Product Change Notice (PCN)

PCN Number: **PCN-0450899R-01**

Product(s) Affected: *SJ1-4251X Series. SJ1-42514, SJ1-42515TS & SJ1-42516*

PREVIOUS CUI DEVICES DETAIL / IMAGE	NEW CUI DEVICES DETAIL / IMAGE

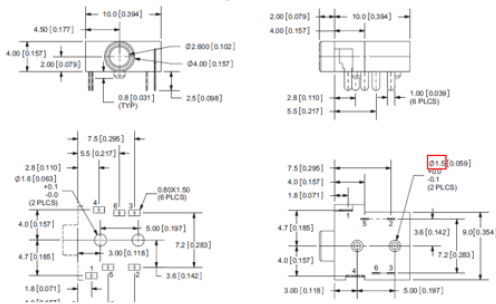
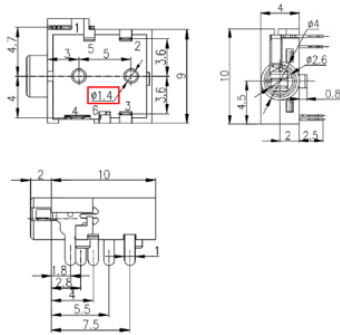
Description of Change: *Locating pin difference and material change. See image Below*

<table border="1"> <thead> <tr> <th></th> <th>MATERIAL</th> <th>PLATING</th> </tr> </thead> <tbody> <tr> <td>terminal 1</td> <td>copper alloy</td> <td>gold flash</td> </tr> <tr> <td>terminal 2</td> <td>copper alloy</td> <td>gold flash</td> </tr> <tr> <td>terminal 3</td> <td>copper alloy</td> <td>gold flash</td> </tr> <tr> <td>terminal 4</td> <td>copper alloy</td> <td>gold flash</td> </tr> <tr> <td>terminal 5</td> <td>brass</td> <td>gold flash</td> </tr> <tr> <td>terminal 6</td> <td>brass</td> <td>gold flash</td> </tr> <tr> <td>plastic</td> <td>PA66</td> <td></td> </tr> </tbody> </table>		MATERIAL	PLATING	terminal 1	copper alloy	gold flash	terminal 2	copper alloy	gold flash	terminal 3	copper alloy	gold flash	terminal 4	copper alloy	gold flash	terminal 5	brass	gold flash	terminal 6	brass	gold flash	plastic	PA66		<table border="1"> <thead> <tr> <th>DESCRIPTION</th> <th>MATERIAL</th> <th>PLATING/COLOR</th> </tr> </thead> <tbody> <tr> <td>terminal 1</td> <td>phosphorous bronze t=0.25</td> <td>gold flash</td> </tr> <tr> <td>terminal 2</td> <td>phosphorous bronze t=0.20</td> <td>gold flash</td> </tr> <tr> <td>terminal 3</td> <td>phosphorous bronze t=0.20</td> <td>gold flash</td> </tr> <tr> <td>terminal 4</td> <td>phosphorous bronze t=0.25</td> <td>gold flash</td> </tr> <tr> <td>terminal 5</td> <td>phosphorous bronze t=0.20</td> <td>gold flash</td> </tr> <tr> <td>terminal 6</td> <td>phosphorous bronze t=0.20</td> <td>gold flash</td> </tr> <tr> <td>housing</td> <td>PA66 [UL94V-0]</td> <td>black</td> </tr> </tbody> </table>	DESCRIPTION	MATERIAL	PLATING/COLOR	terminal 1	phosphorous bronze t=0.25	gold flash	terminal 2	phosphorous bronze t=0.20	gold flash	terminal 3	phosphorous bronze t=0.20	gold flash	terminal 4	phosphorous bronze t=0.25	gold flash	terminal 5	phosphorous bronze t=0.20	gold flash	terminal 6	phosphorous bronze t=0.20	gold flash	housing	PA66 [UL94V-0]	black

MATERIAL	PLATING																																															
terminal 1	copper alloy	gold flash																																															
terminal 2	copper alloy	gold flash																																															
terminal 3	copper alloy	gold flash																																															
terminal 4	copper alloy	gold flash																																															
terminal 5	brass	gold flash																																															
terminal 6	brass	gold flash																																															
plastic	PA66																																																
DESCRIPTION	MATERIAL	PLATING/COLOR																																															
terminal 1	phosphorous bronze t=0.25	gold flash																																															
terminal 2	phosphorous bronze t=0.20	gold flash																																															
terminal 3	phosphorous bronze t=0.20	gold flash

terminal 4	phosphorous bronze t=0.25	gold flash																																															
terminal 5	phosphorous bronze t=0.20	gold flash																																															
terminal 6	phosphorous bronze t=0.20	gold flash																																															
housing	PA66 [UL94V-0]	black
